GROUP	MODEL
Safety Recall Campaign	2012-2013MY Optima (QF)
NUMBER	DATE
SC284QF (Rev 1, 9/25/2024)	April 2024

HECU MULTI FUSE REPLACEMENT (SC284QF)

This bulletin has been revised to include additional information. New/revised sections of this bulletin are indicated by a black bar in the margin area.

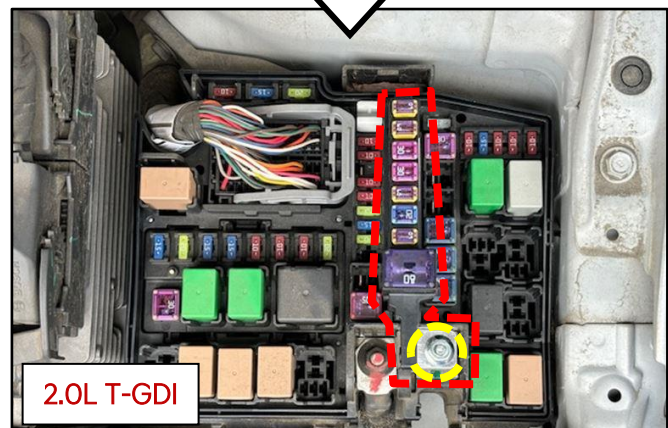
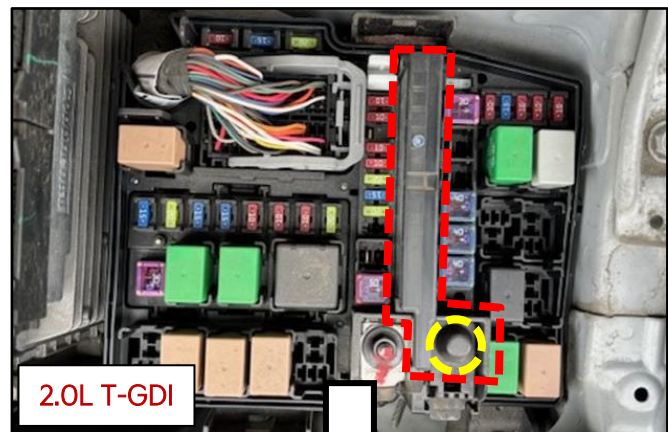
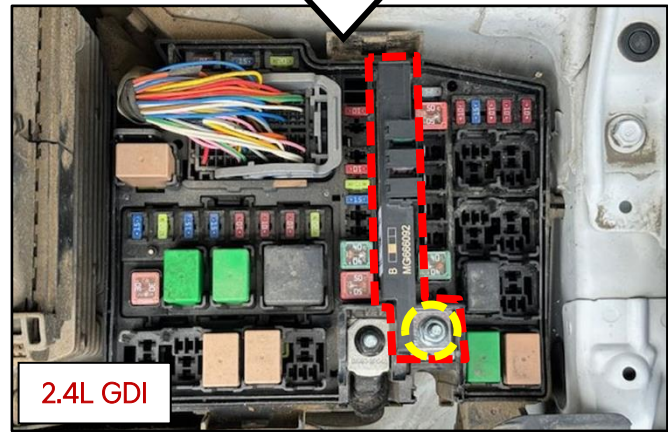
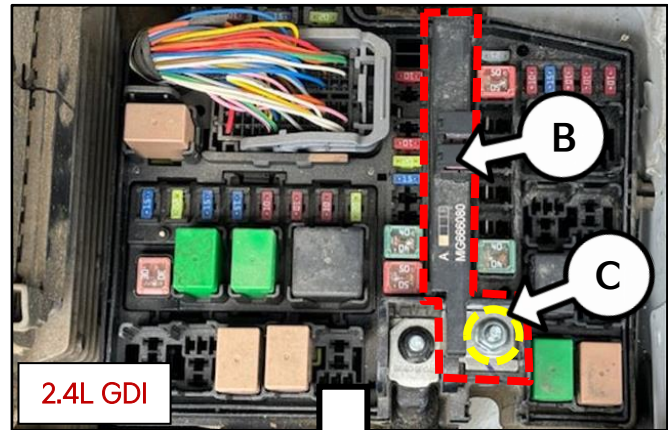
- 5a. Locate the Multi Fuse (B) for ABS1 and loosen the 10mm Multi Fuse retaining nut (C) and remove the Multi Fuse.
- 5b. Install the **new** Multi Fuse (B) and tighten the retaining nut (C).

Note: The Multi Fuse designs differ between 2.4L GDI and 2.0L T-GDI vehicles.

Note: Drill a hole through the center of the removed Multi Fuse. DO NOT reuse.

Tightening torque for retaining nut (B):
7.2 - 8.7 lb.ft (9.8 - 11.8 N.m)

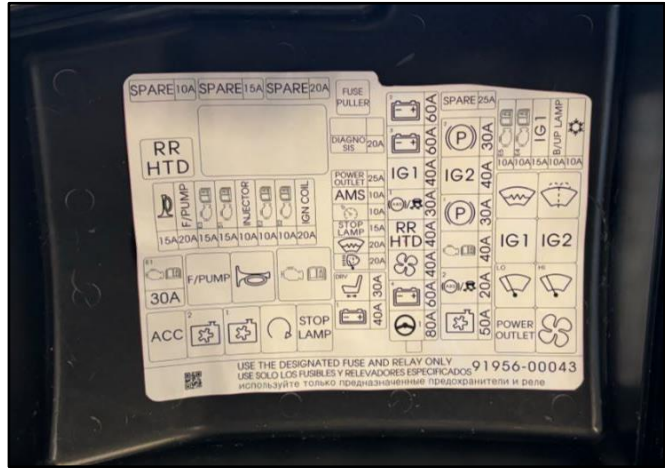
- 6. Adhere the new fuse label to the bottom of the new junction box fuse cover, as shown.
